CRANE BARGE

INVITATION TO BID – REQUISITION NO. 2020-0814

ADDENDUM NO. ONE (1) – DATED AUGUST 7, 2020

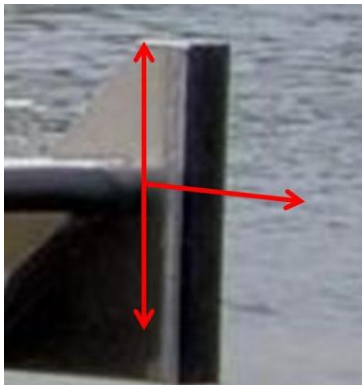
Question #1: Is there a sketch or drawing depicting the proposed arrangement of the specified deck house showing the crane, etc.?

Answer: The house is aft on the deck and the crane is forward allowing the cargo (loading area) in between the two. The image below is a very primitive sketch. We defer to the manufacturer's advice.
